Wellington Village (FKA K Park)

STAFF REPORT

Petition Numbers: Rezoning
 2025-0003-REZ
 Ordinance No. 2026-06

Master Plan
 2025-0001-MP
 Resolution No. R2026-03

Image D: Landscape Buffers

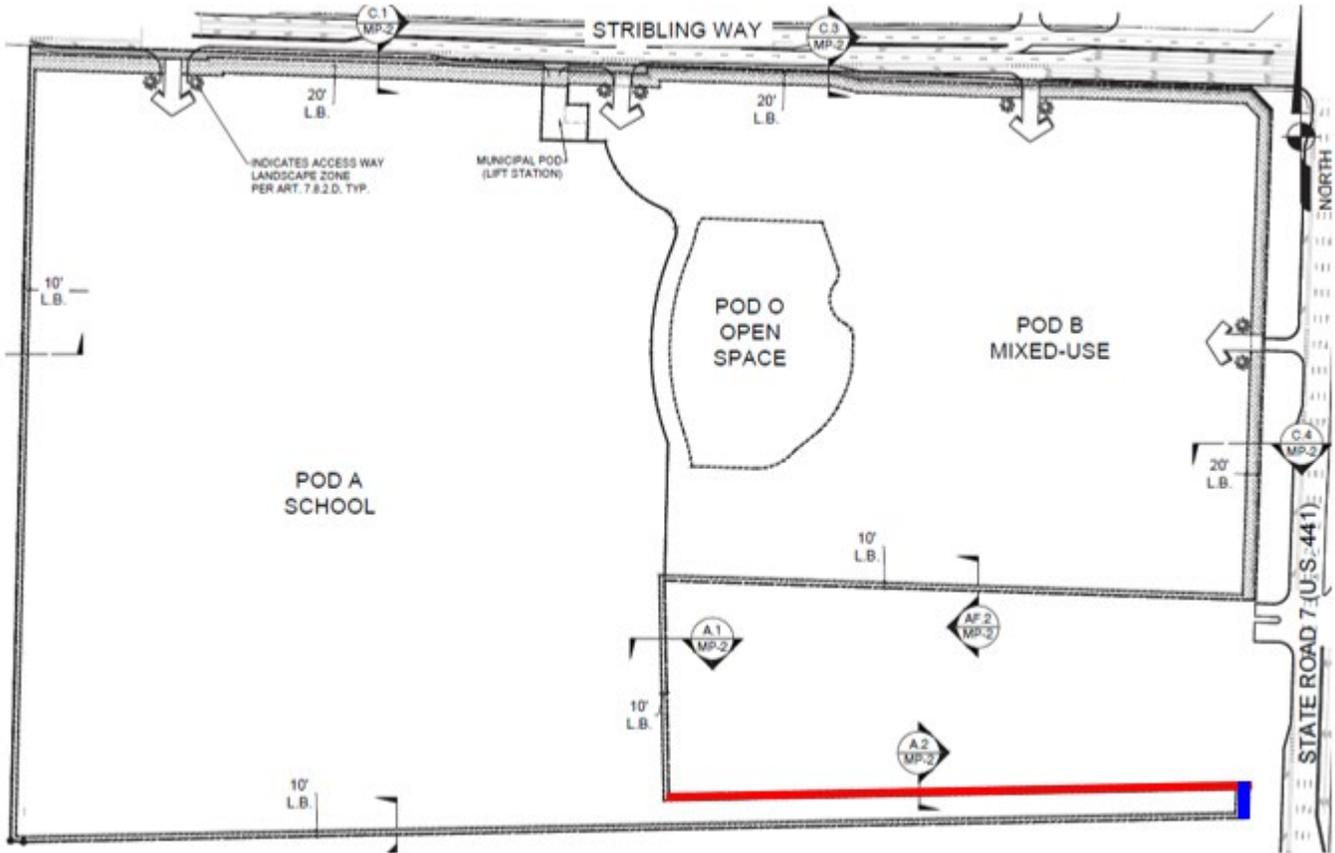
9. **Type A/F Buffer (South Property Line):** A landscape buffer deviation is requested to eliminate the required fence within Type A/F buffer for the eastern portion of the southern property line between the proposed control access gates and SR 7 (shown as blue line in Image D). A modified Type A/F buffer is provided along the south side of Pod A, consisting of a proposed masonry wall at a minimum of 6 feet in height located at the property line and terminating at the southern gate access into Pod A. The eastern portion of the southern property line, where a wall is not proposed, does not contain any building square footage or active uses; it consists solely of a driveway that provides access to

the school site from the roundabout located on the Church property and landscape open space consisting of a dry detention swale. Additionally, an existing landscape buffer along the northern property line of Farmington Estates, the residential community to the south, provides further screening for the areas where a wall is not proposed. The applicant is also proposing a masonry wall in lieu of the required fence, providing a higher quality aesthetic and improved site security compared to the fence that is typically required in a Type A/F buffer. There is no objection to this request.

10. **Landscape Buffer Perimeter Path:** Per Section 6.5.4.7 of Wellington’s LDR, a minimum width of

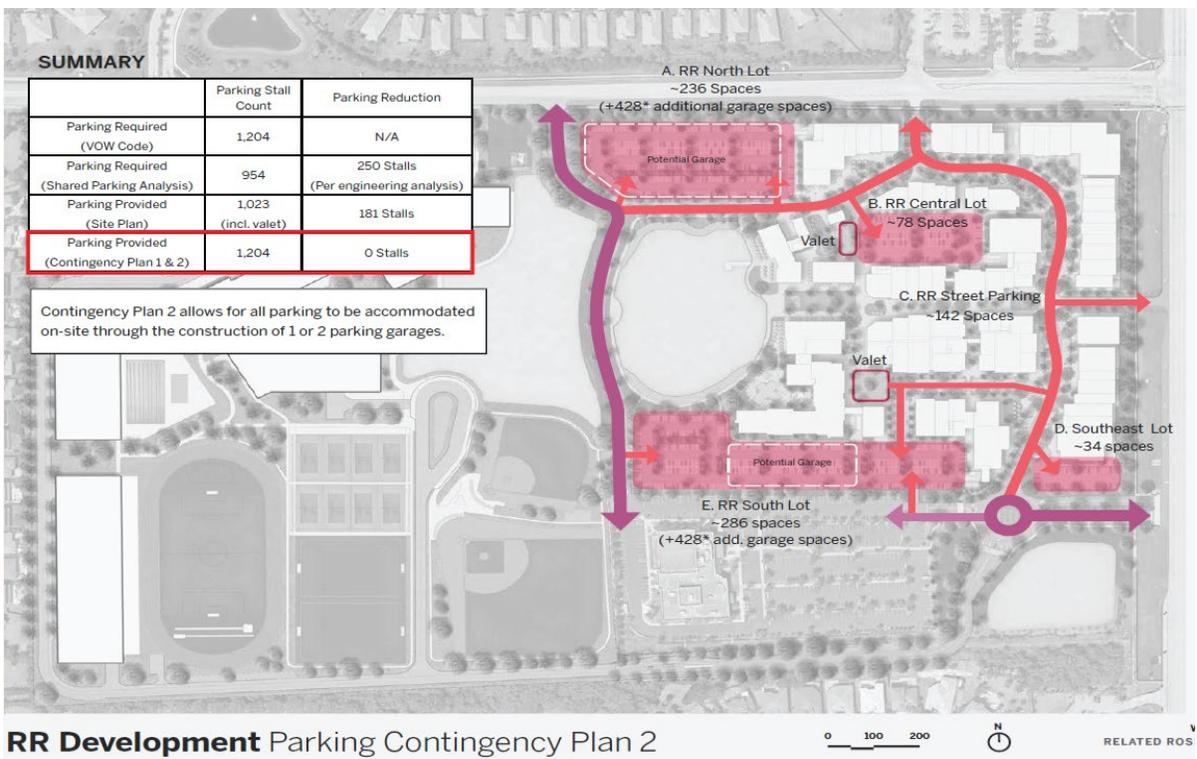
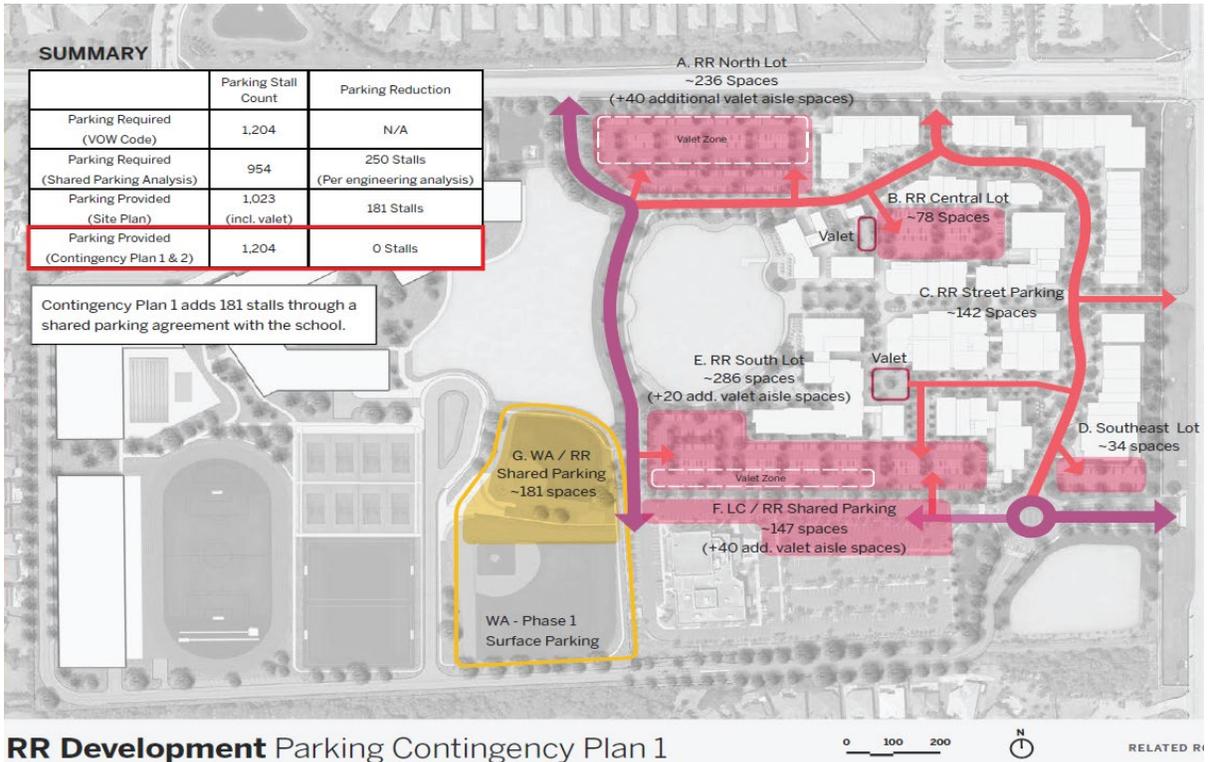
10 feet shall be added to the minimum width of a perimeter landscape buffer to accommodate the path's construction. This requirement would apply to the north and eastern perimeter of the MUPD where adjacent to Stribling Way and State Road 7. The Pod A buffer adjacent to Stribling Way proposes a buffer width of 20 feet and a 10-foot perimeter utility easement. In lieu of an additional 10 feet, the project proposes to maintain the existing sidewalk widths within the adjacent ROW's, as there is an existing pathway. There is no objection to this request.

Image H: Pod B Landscape Buffer

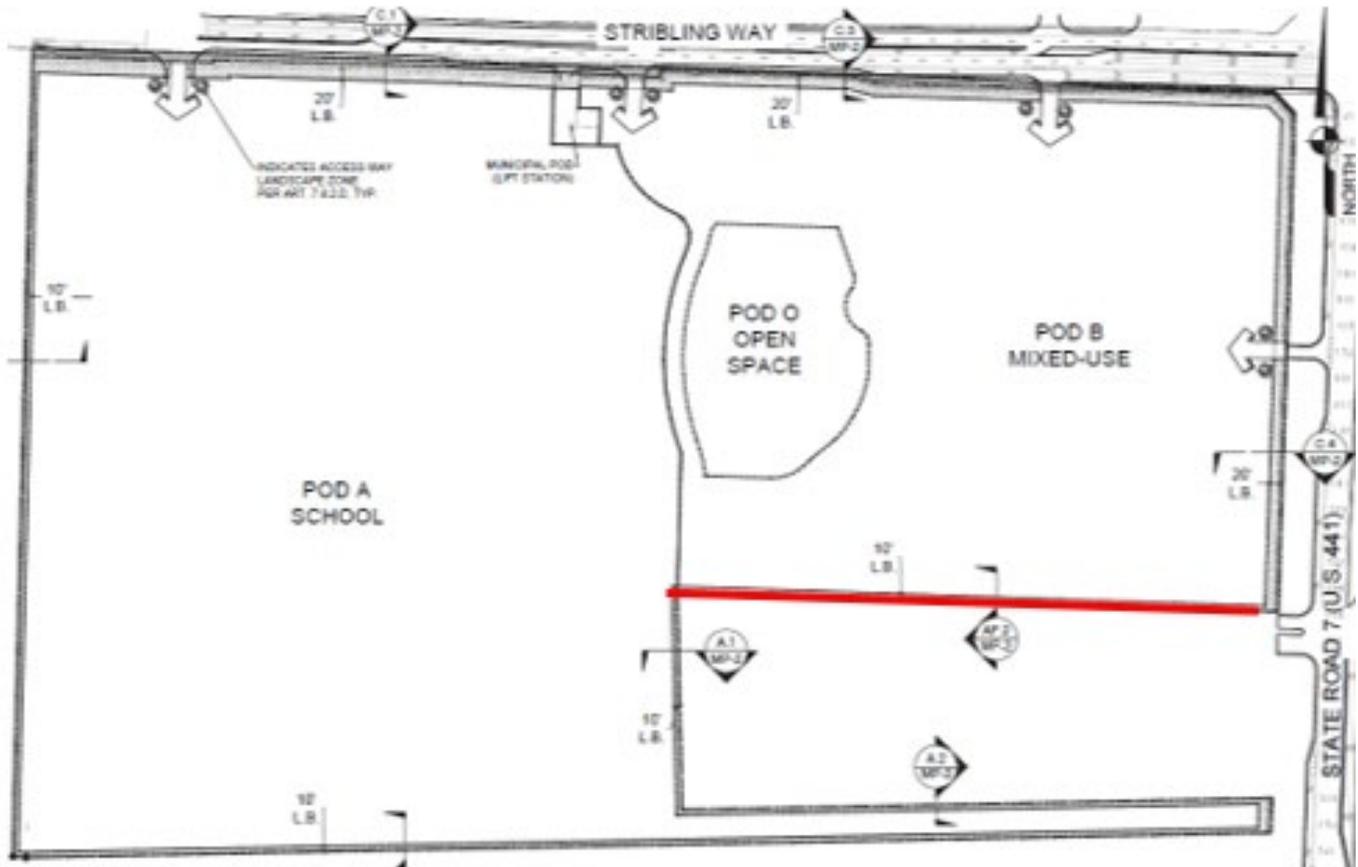
7. **Buffer Type A/F (South):** A landscape buffer deviation is requested to eliminate the required fence within Type A/F buffer for the southern property line adjacent to the Life Church property (shown as red line in Image H) at the request of Life Church. There is no objection to the request.
